# ACCESS REPORT

PROJECT: New primary school at Wilton Junction  
PROJECT NO: GDL240470  
PREPARED FOR: The NSW Department of Education (DoE)  
REVISION: D  
DATE: 21.02.2025

## **7.0 APPENDIX B – MARKUPS**

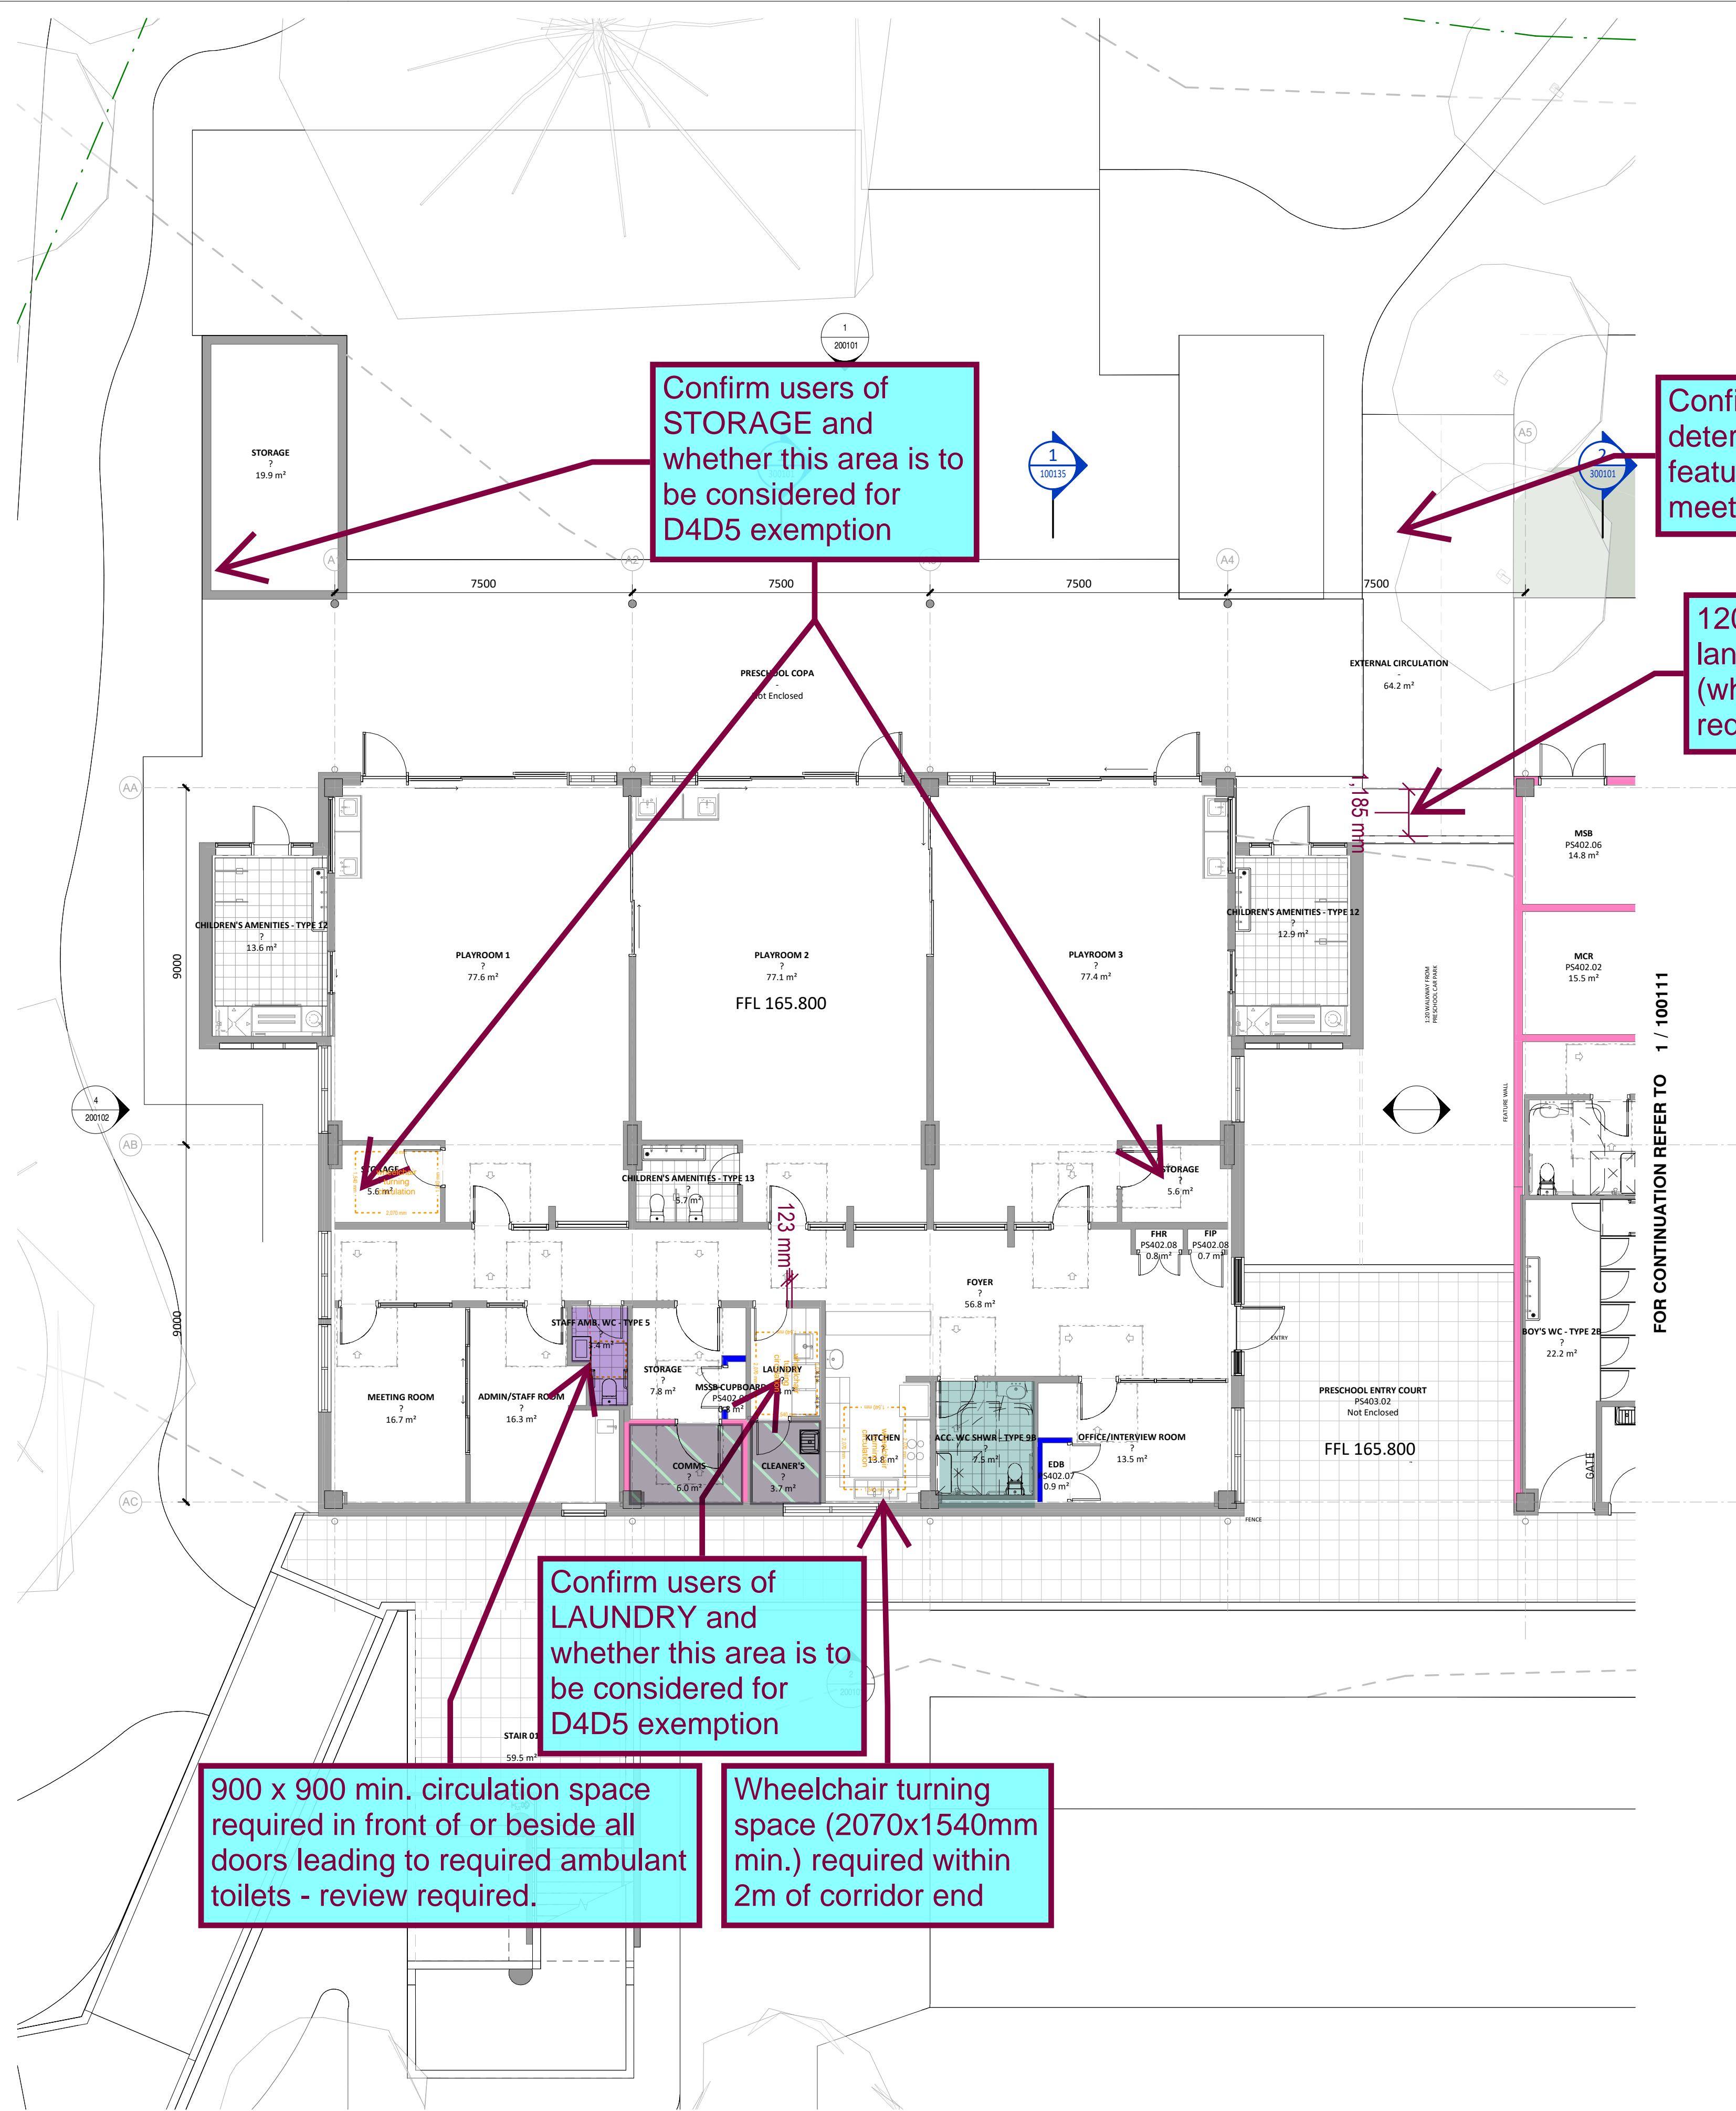
Confirm users of STORAGE and whether this area is to be considered for D4D5 exemption

**Title**  
10 - GENERAL ARRANGEMENT PLANS  
GA - BUILDING A - ZONE 3 -  
GROUND FLOOR  
0 1 2 5 8m  
As indicated@A1  
**Drawing Number** WJPS-PTW-B00A-GF-DR-A-100121  
**Revision** 2  
**Phase**  
SCHEMATIC DESIGN

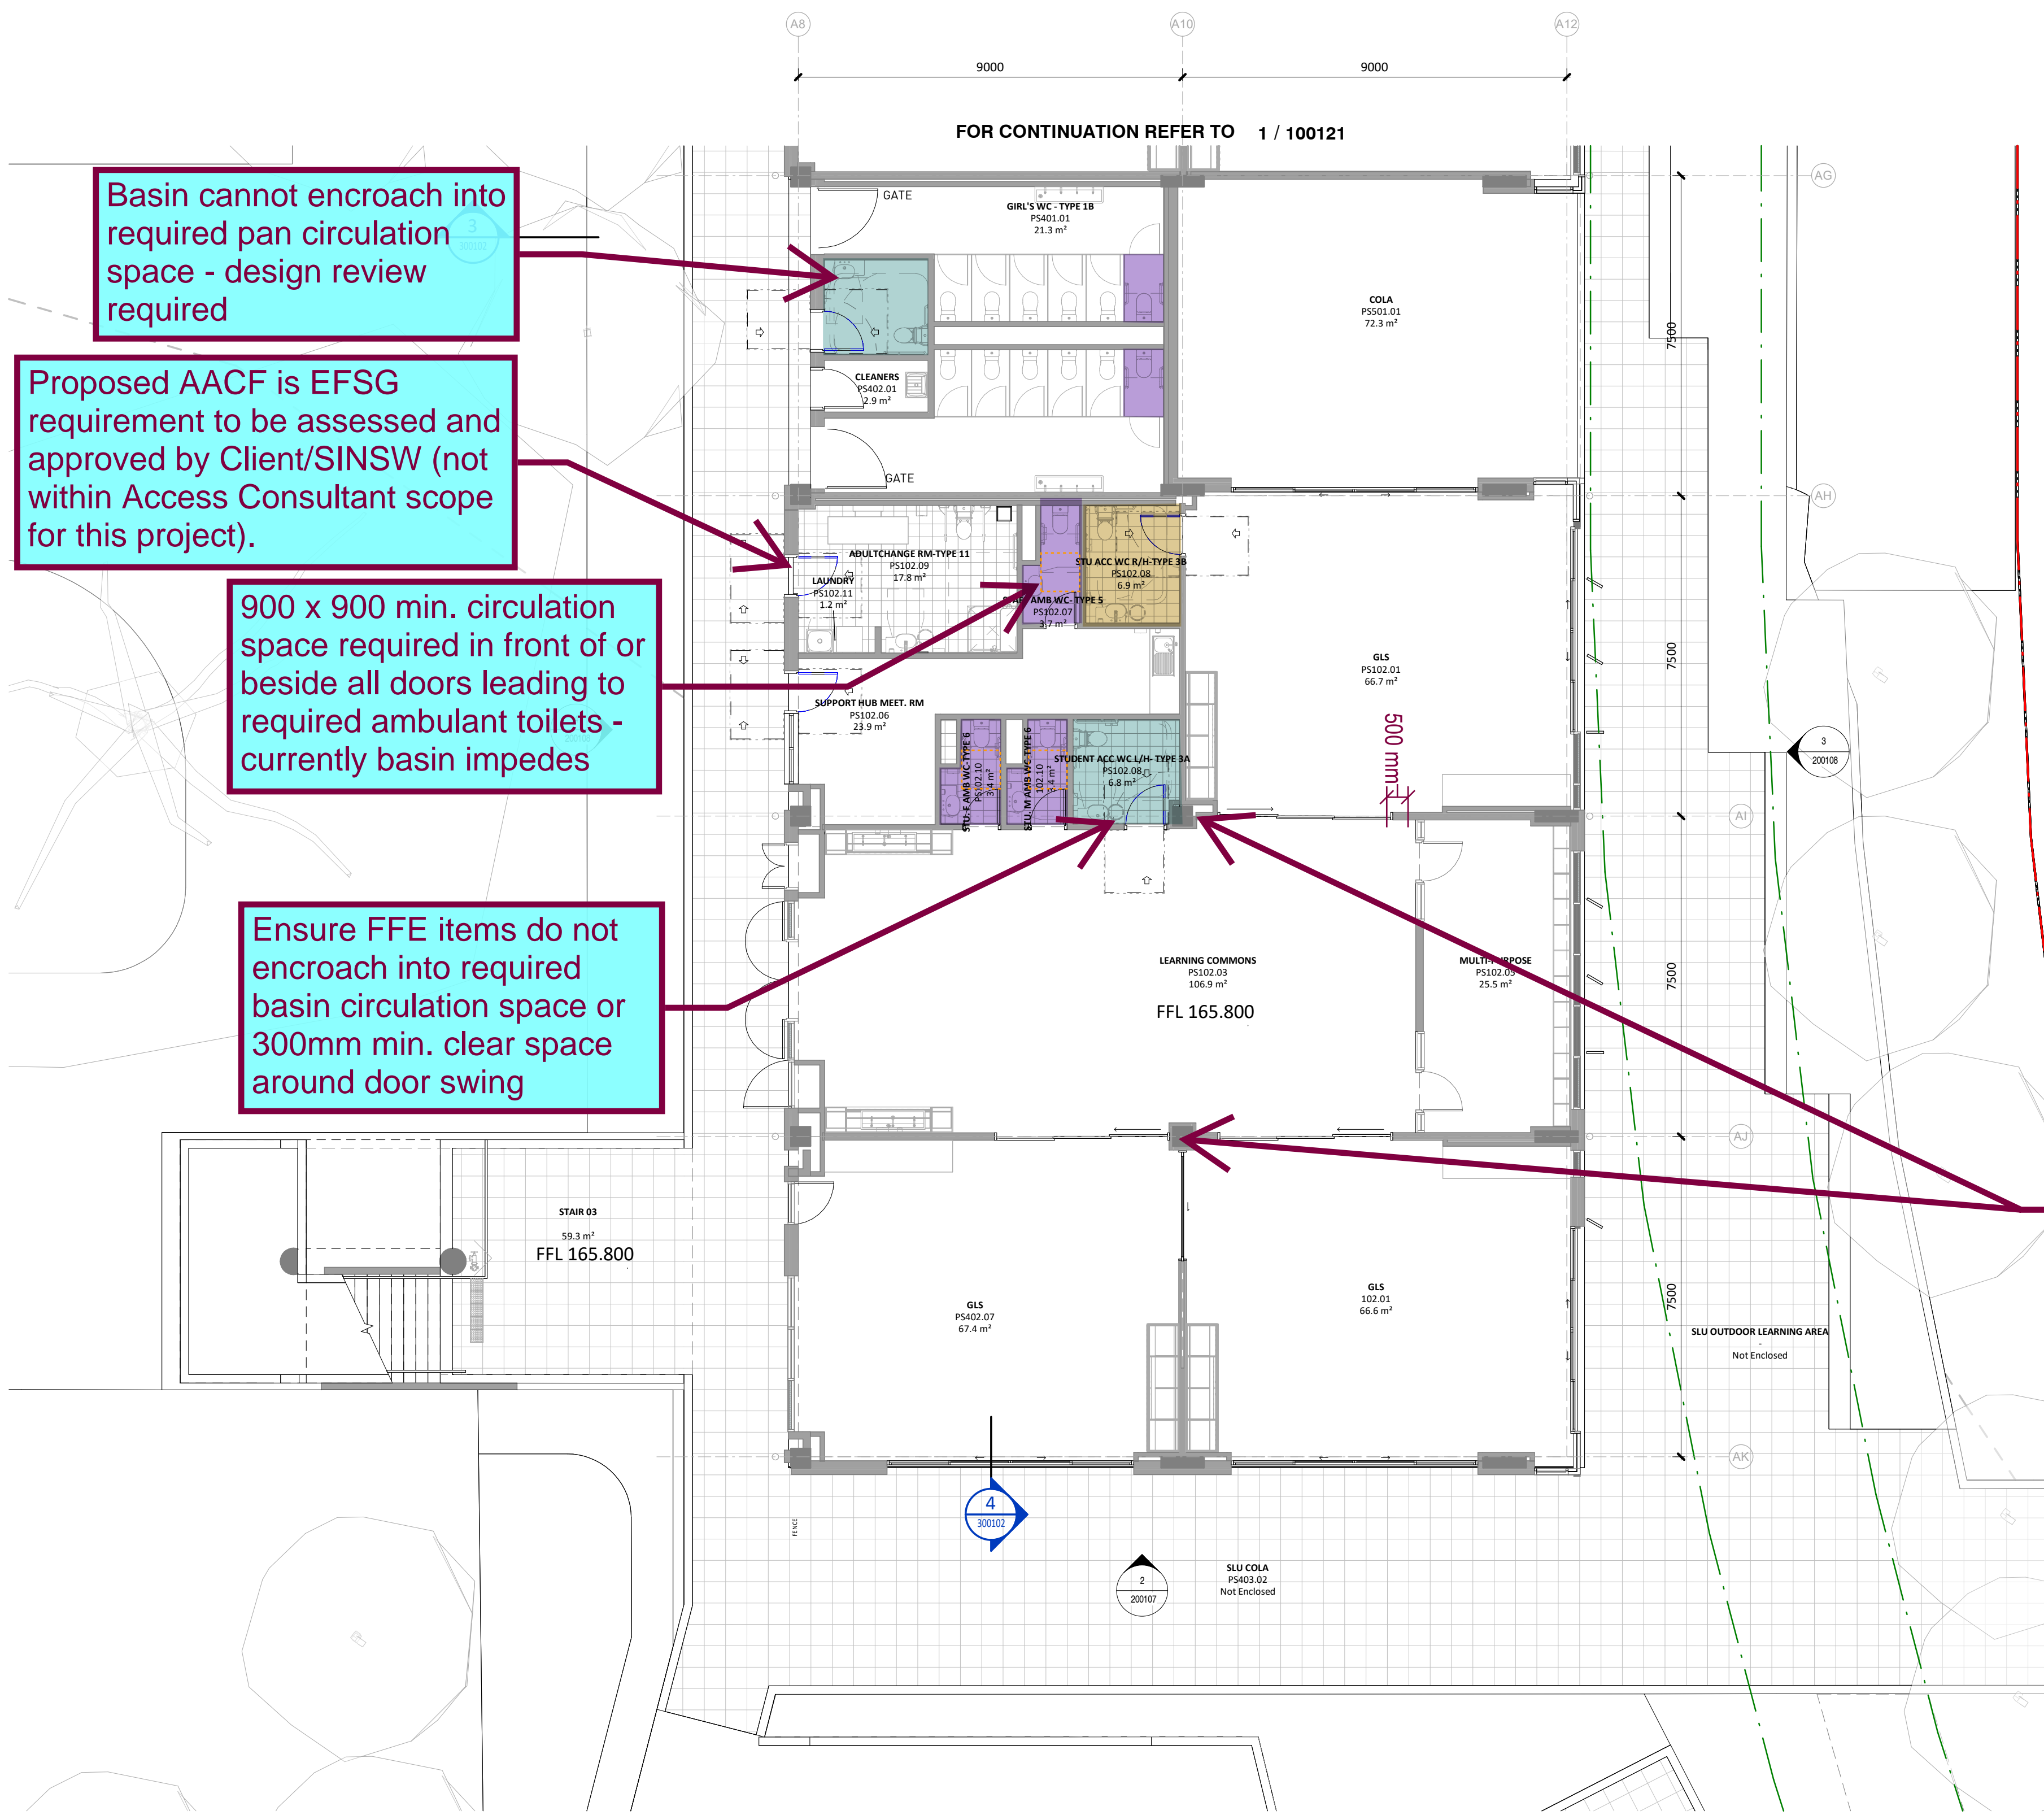
GLS sliding doors do not provide 530mm min. latch side clearance - common issue throughout multiple areas. Performance solution required. PS justification would require off-set handle (400mm min. from leading door edge for slide-side approach) and lightweight door operation to meet AS1428.1.

10 - GENERAL ARRANGEMENT PLANS  
GA - BUILDING A - ZONE 2 -  
LEVEL 1

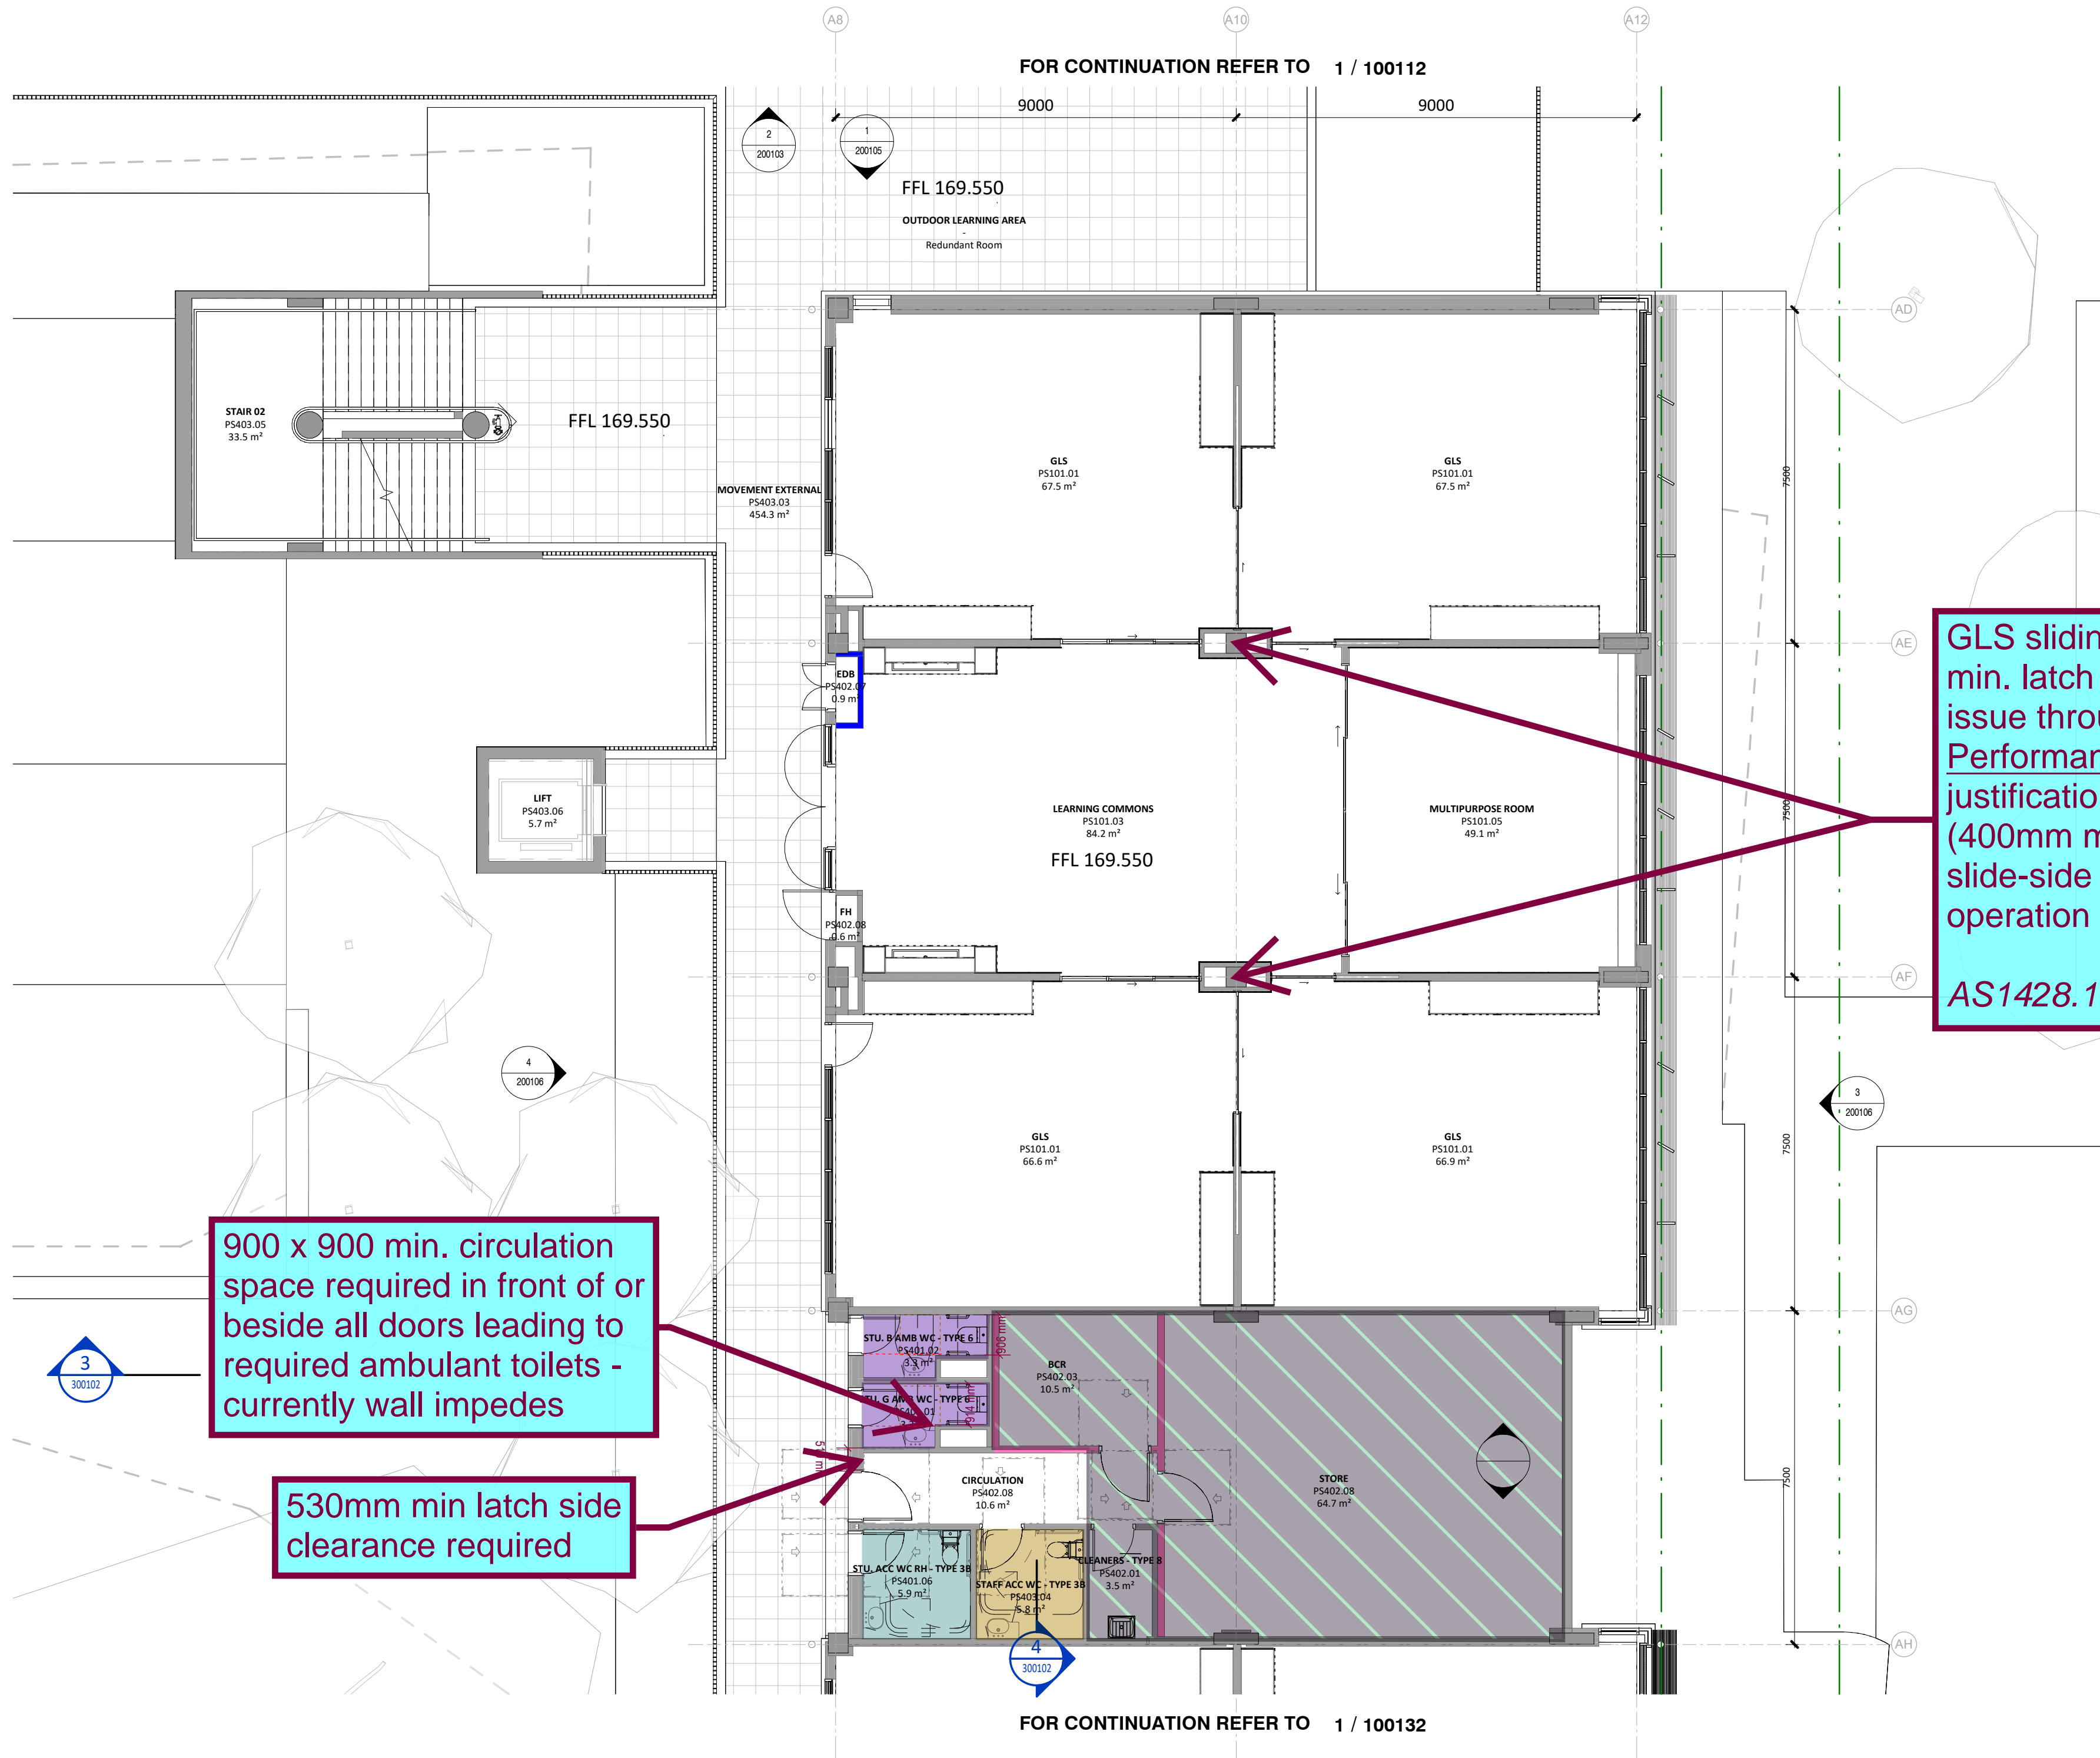
GLS sliding doors do not provide 530mm min. latch side clearance - common issue throughout multiple areas. Performance solution required. PS justification would require off-set handle (400mm min. from leading door edge for slide-side approach) and lightweight door operation to meet AS1428.1.

AS1428.1 Cl. 13.3.3

900 x 900 min. circulation space required in front of or beside all doors leading to required ambulant toilets - currently wall impedes

530mm min latch side clearance required
